**RE: Initial Submission Review – Lone Tree North Lateral Gas Pipeline No 6 – Site Plan Amendment**  
Application Number: **DA-2235-06**  
Case Number: **2020-6017-06**

Westwood Professional Services, Inc. (Westwood) has received comments, dated October 12, 2021 from the City of Aurora Oil & Gas Division, Arapahoe County Public Works and Development, the Mile High Flood District, and Tri-County Health for the above referenced project. We have restated the comments below and addressed them per the bold, italicized responses.

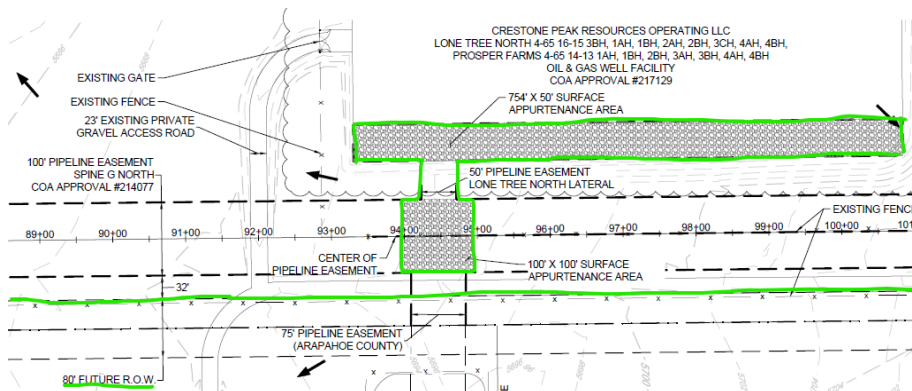
Comment: Hayesmount Rd is a county road and the since the pipe installation is in the right of way, Construction drawing. GESC Plan should be submitted to the County for review.

Comment: Street cut right of way permit from Arapahoe county should be applied before construction can commence.

Comment: There should be a roadway agreement between Arapahoe county and applicant.

***Response: The limits of disturbance for this lateral is not within the Arapahoe County or any other Right-of-Way. This amendment to the existing Site Plan is for the Lone Tree Lateral to accommodate Phase 2 of the Lone Tree Well Pad. The screenshot below shows the disturbance for this project and the limits of the county future Right-of-Way.***

***Response: See the response to the comment above.***

***Response: See the response to the comment above.***
